Comair, Inc.
Lexington, KY
August 27, 2006
DCA06MA064

ATTACHMENT 13

FAA EMAIL TO JEPPESEN (DATED 6/23/06)

To [REDACTED], [REDACTED]
Document.Control.Denver@jeppesen.com,
[REDACTED], [REDACTED]
cc
bcc
Subject Airport Diagram/Sketch Revision, Lexington, KY., LEX,
AL-697

AIRPORT DIAGRAM

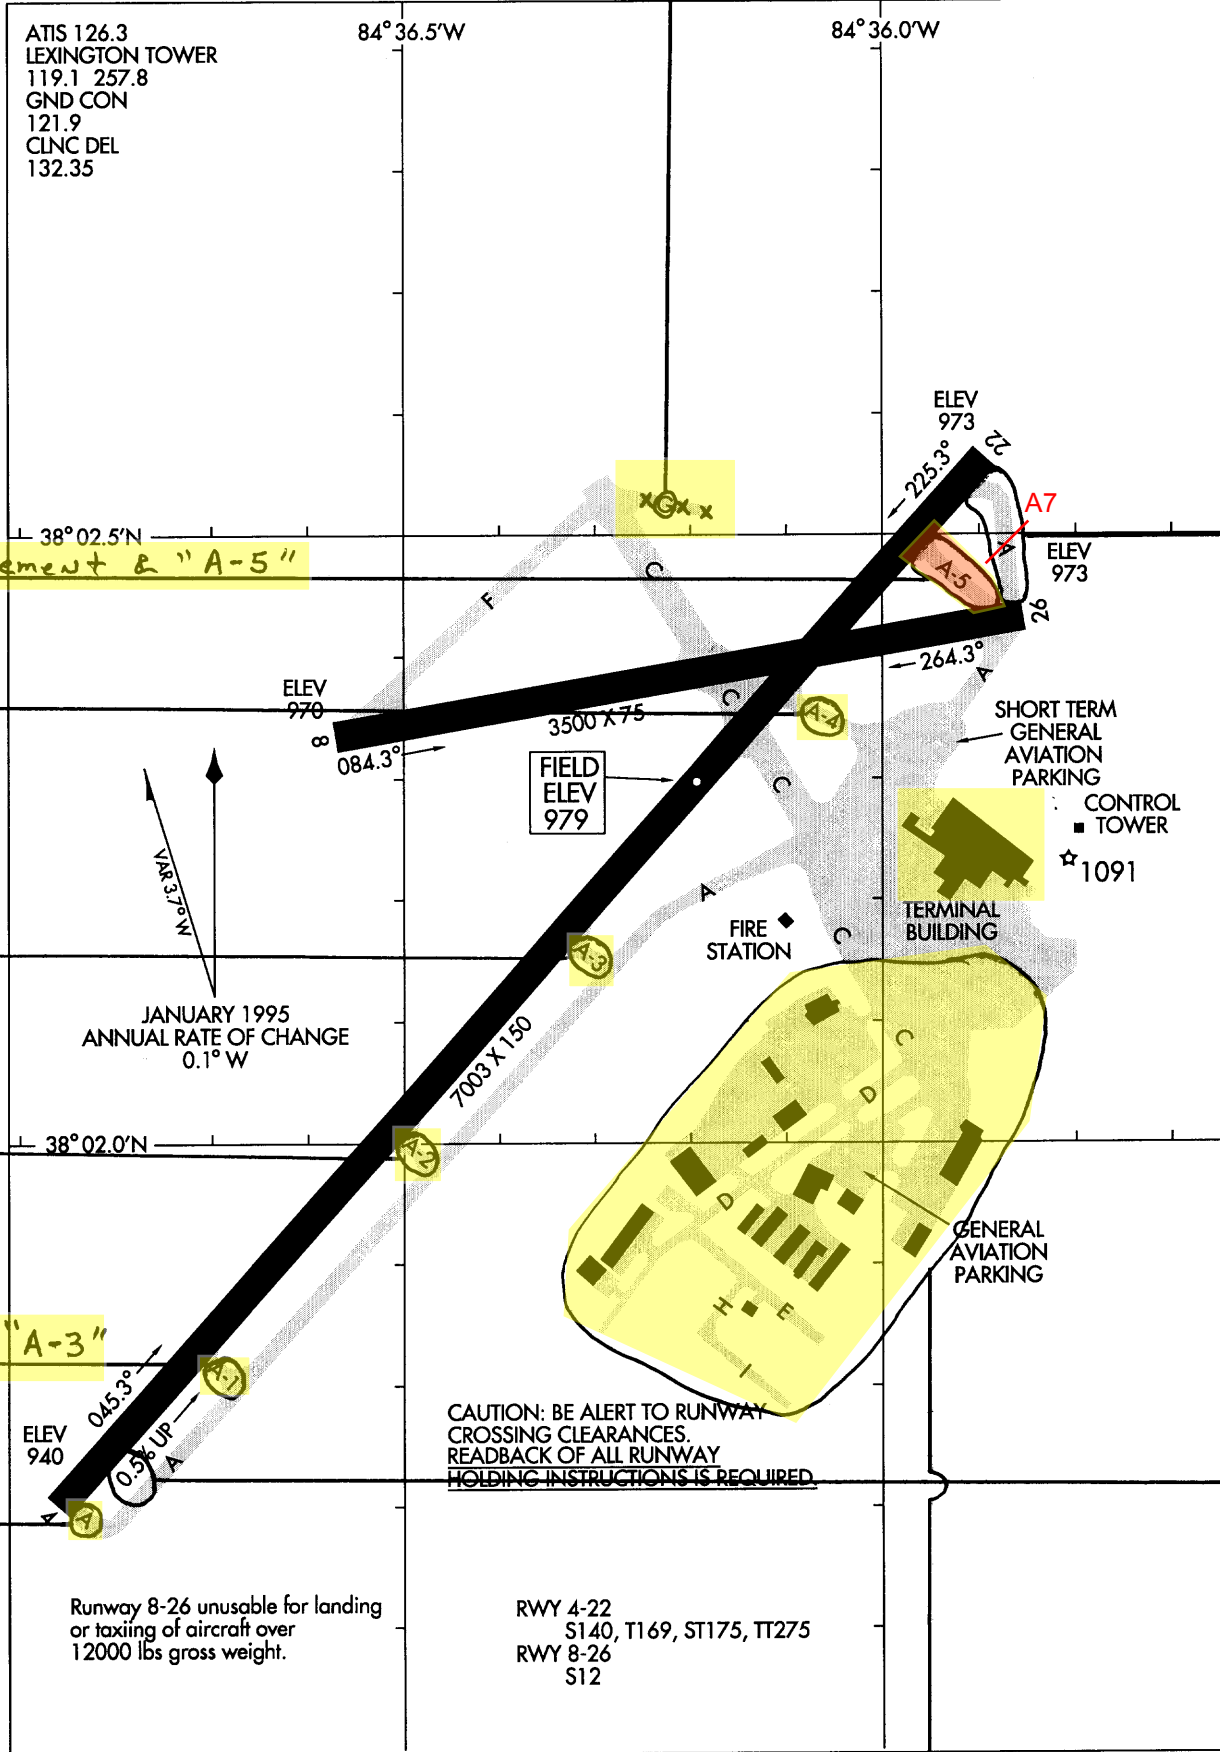
Delete "G" & Add closed taxiway symbols

Revise pavement per file LEX part2 & add "A-7"

Delete pavement & "A-5"

change to "A-6"

change to "A-5"

change to "A-4"

change to "A-3"

change to "A-1"

AIRPORT DIAGRAM

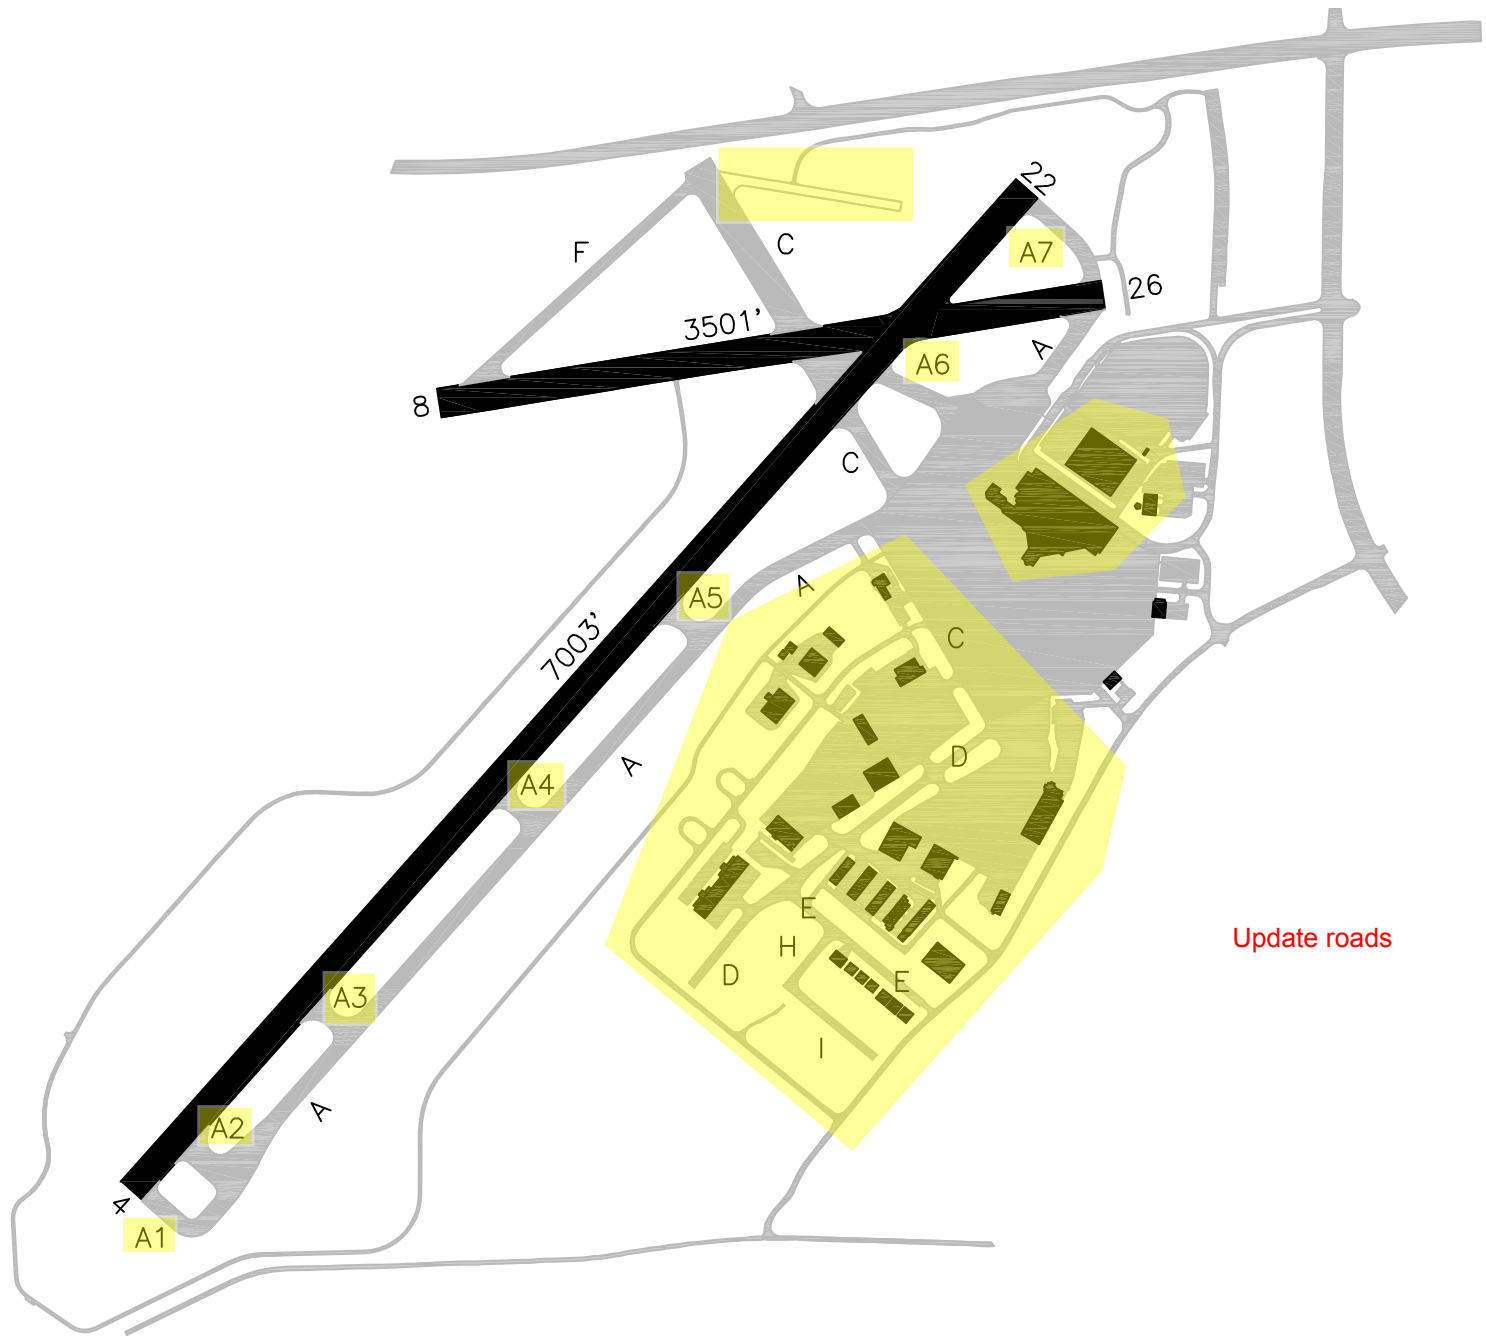
Add pavement per file LEX part2 & add "A-2"

Update roads
